## TECHNICAL NOTE TN-1025

### Reciter May Reset when Calibrating VCO Lock Range

27 May 2005

## 2. Locating R713

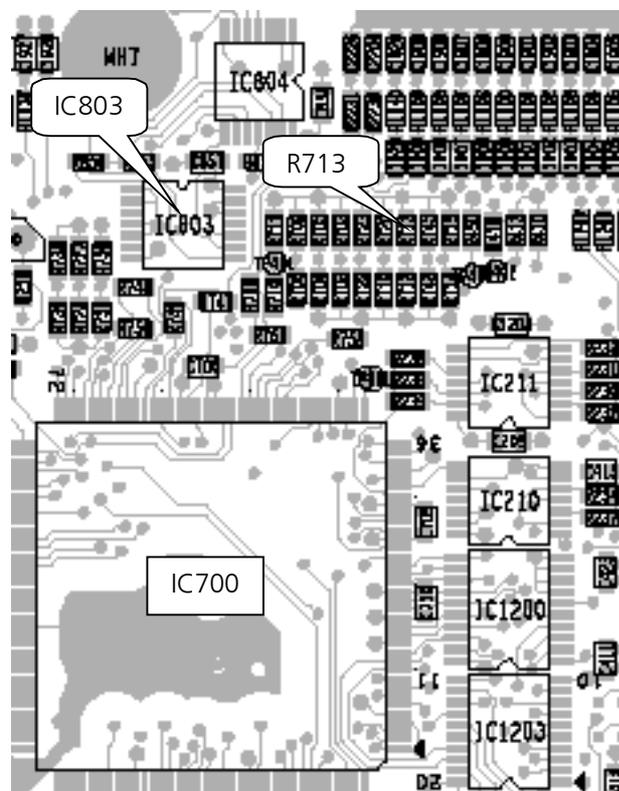
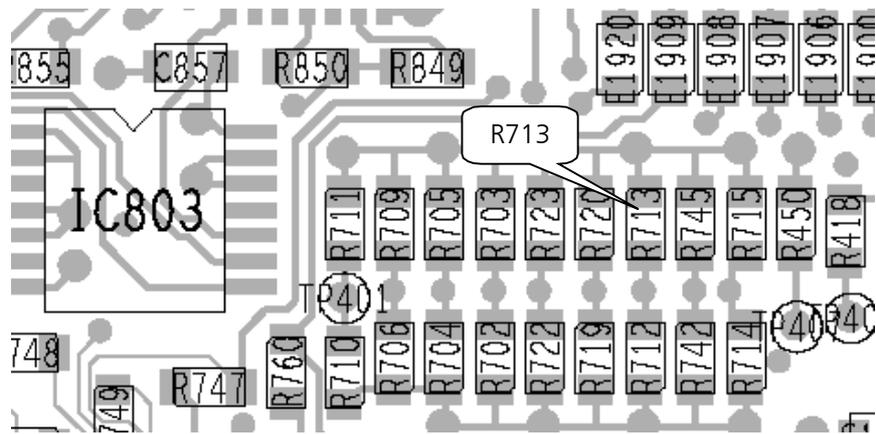
A reciter reset issue has been noted in manufacturing. If this is an issue with any reciter in the field, it will be seen when adjusting the VCO lock range with the Calibration Kit software. The long-term fix for the problem involves adding a D flip-flop when the digital board is re-designed. In the mean time, a simple fix for any reciters that show this problem while the VCO is being adjusted is to add a 10pF capacitor (IPN 018-12100-10) in parallel with R713.

R713 is located on the digital board near IC700. See the 2 pictures below. Fit a 10pF capacitor (IPN 018-12100-10) on top of R713.
